**PARTS & SERVICE
NEWS**

REF NO.	AT04090
DATE	May 21, 2004

SUBJECT: REPAIR PROCEDURE FOR EXHAUST MANIFOLD GASKET FOR SA12V140 ENGINES

PURPOSE: To introduce modification procedure to repair the breakage failure of the exhaust manifold gasket for the SA12V140 engines

Fig. 1

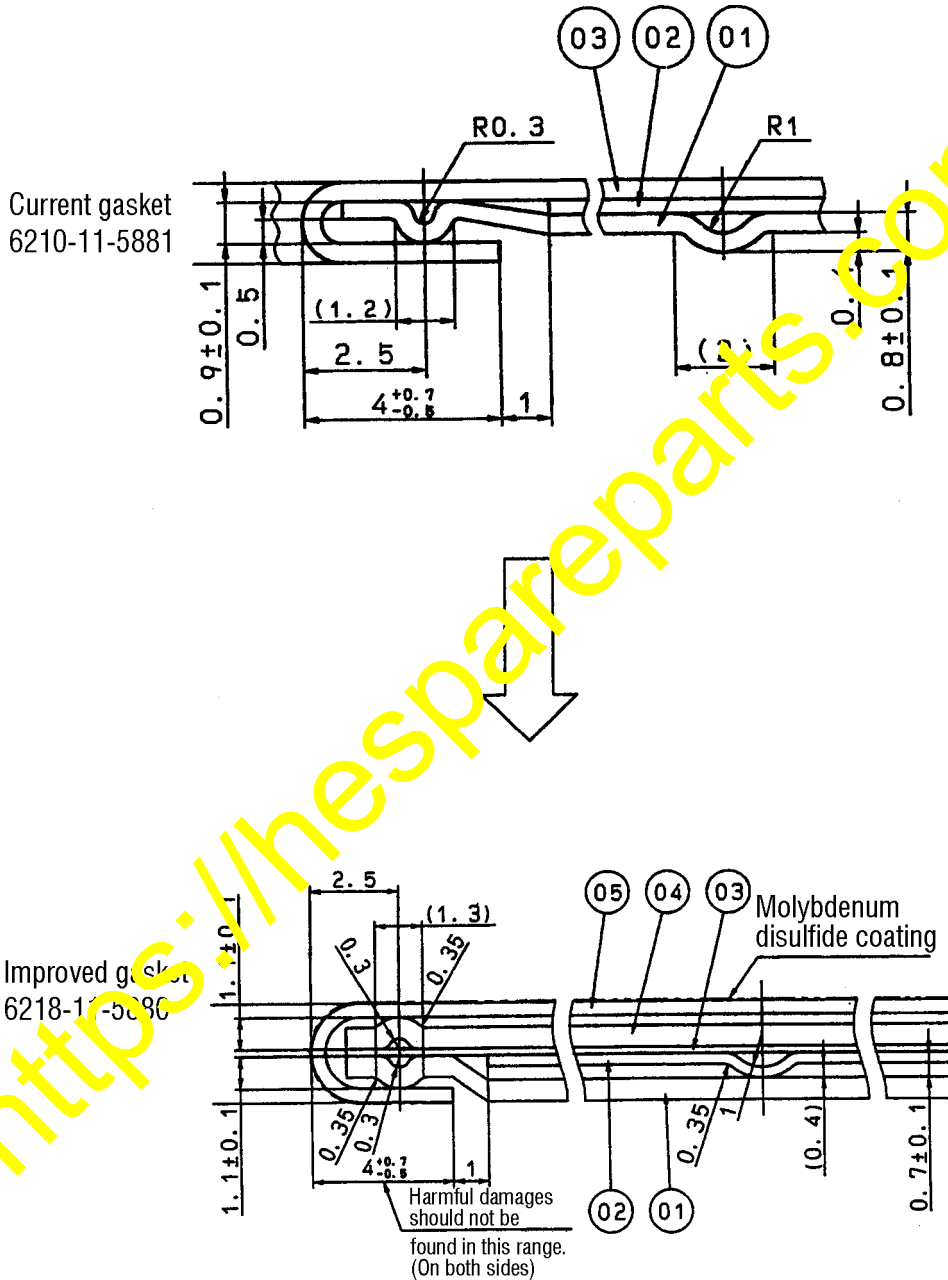
- (1) Molybdenum disulfide coating is being applied to the exhaust manifold gasket on the contact surface side to the exhaust manifold.
(Even if the exhaust manifold moves by thermal deformation, the gasket will slip to avoid deformation. (To suppress the occurring stress))
- (2) The structure of the gasket has been changed from 3 layer structure to 5 layer structure to equalize the surface pressure of the gasket, and also, to suppress relative deformation.
